RS-14-266

**Subject:** Withdrawal and Resubmittal of Information associated with NRC Set 10 RAIs, related to the Byron Station, Units 1 and 2, and Braidwood Station, Units 1 and 2, License Renewal Application

**Byron and Braidwood Stations (BBS), Units 1 and 2  
License Renewal Application  
Responses to Requests for Additional Information**

**Figure 1: Total and Primary Plus Secondary Stress Intensity Peaks for a RCL Safety Injection Nozzle Transient**

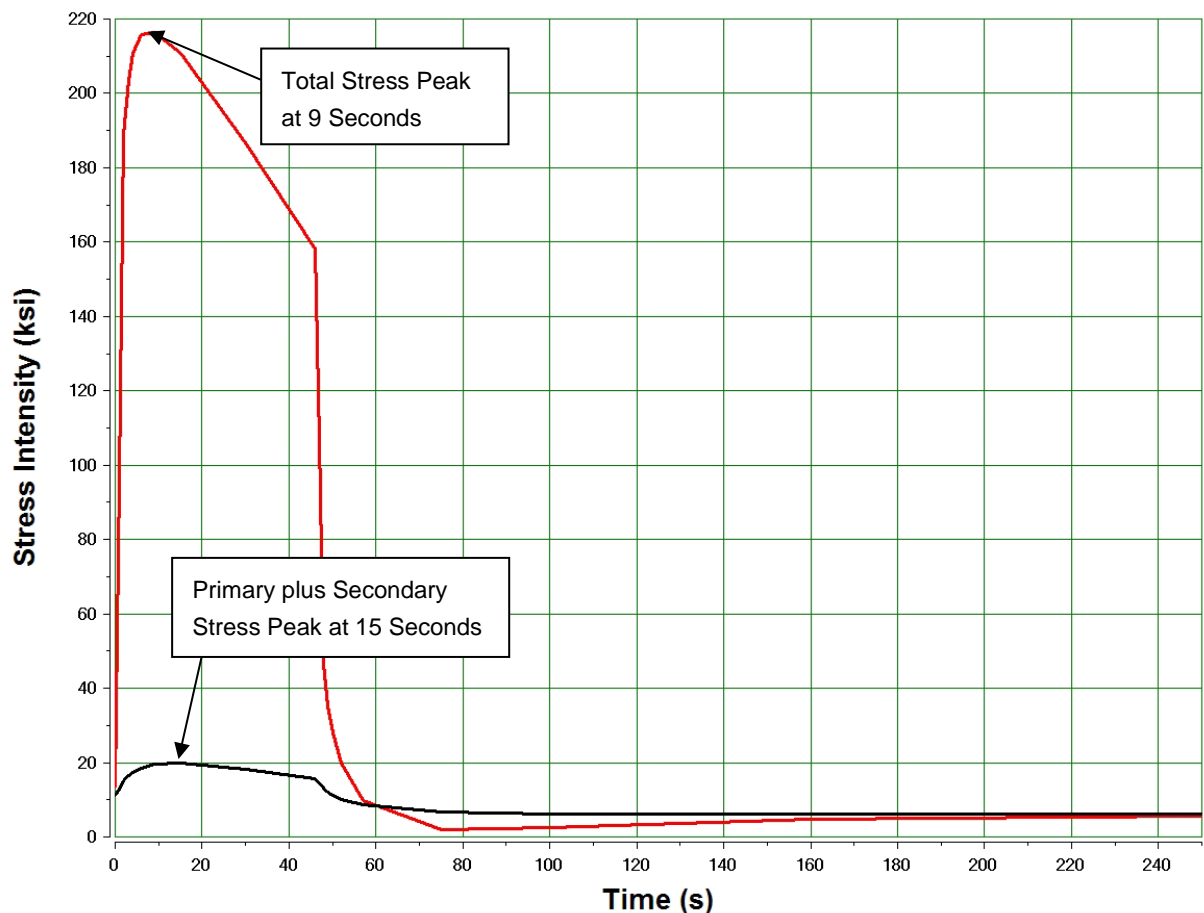
1. Clarify whether any of the fatigue evaluation has used these “optional program tools” to remove conservatism.
  - a) If so, identify all the fatigue evaluations in which these “optional program tools” were used. Provide three examples in which these “optional program tools” were used. For each example, provide the basis for the removal of conservatism and justify that a more accurate final result was produced.

Figure 1 shows a plot of Total stress intensity and Primary plus Secondary stress intensity for a Reactor Coolant Loop Safety Injection Nozzle transient used in the fatigue evaluation. [

] <sup>a,c,e</sup> Even though the curve shows a total stress peak greater than the primary plus secondary stress peak, the total stress peak at 41 seconds contributed less to the alternating stresses in the initial fatigue evaluation than the Primary plus Secondary stress peak at 73 seconds and was determined to be non-controlling and redundant. Therefore, based on the criteria in the WESTEMS™ User's Manual, the peak time at 41 seconds for this transient was removed from the fatigue restart file and the fatigue calculation was re-run. Due to consideration of the controlling peak times, the analysis resulted in the removal of unnecessary conservatism and more accurate usage factors.

**Figure 1 - Example of Cold Leg Safety Injection Accumulator Piping Components and Respective Transient Sections**

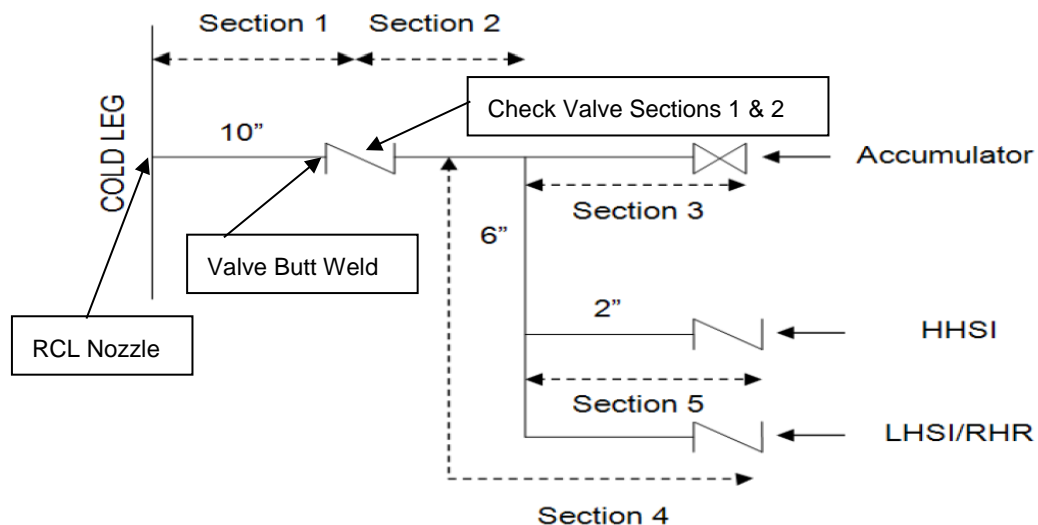
1. Identify the locations that were compared from different transient section, but within a common system or piece of major equipment, and the component that was eliminated. A sample set of locations and eliminated component(s) may be provided: however, a justification of sufficient detail is necessary to explain that this sample set is bounding for the population of compared locations and eliminated component(s).
2. For each of these situations, provide the basis for the comparison that was made for different transient sections but within a common system or piece of major equipment. In addition, provide the basis for eliminating the component(s) that was eliminated for consideration of EAF. As part of these justifications, specifically address any assumptions, factors or criteria that were applicable when implementing this comparison.

1. Based on the process described in the response to Request 2, all locations within each piping system or major equipment with a fatigue analysis were addressed and compared, and all but the identified leading locations were justified to be eliminated. An example of the comparison between transient sections as a result of applying the process for one piping system is provided here. The example is for the cold leg safety injection accumulator piping transient section 1 (as shown in Figure 1 below), which extends from the reactor coolant loop (RCL) cold leg to the first check valve, and transient section 2, which extends from the first check valve to the safety injection branch line. This system is considered as a bounding example since the safety injection nozzle (RCL Nozzle) is a NUREG/CR-6260, "Application of NUREG/CR-5999 Interim Fatigue Curves to Selected Nuclear Power Plant Components" location. In addition, these sections are bounding representations for this system, since the transients and components in transient sections 1 and 2 are similar or more limiting than those in transient sections 3, 4, and 5. Figure 1 illustrates the system transient sections and the accompanying Table 1 below illustrates the result of using the EAF screening process and determination of a leading location when comparing two transient sections.

The transient sections for the cold leg safety injection accumulator piping system were determined in the current licensing basis fatigue evaluation. See Figure 1 of Response 1.
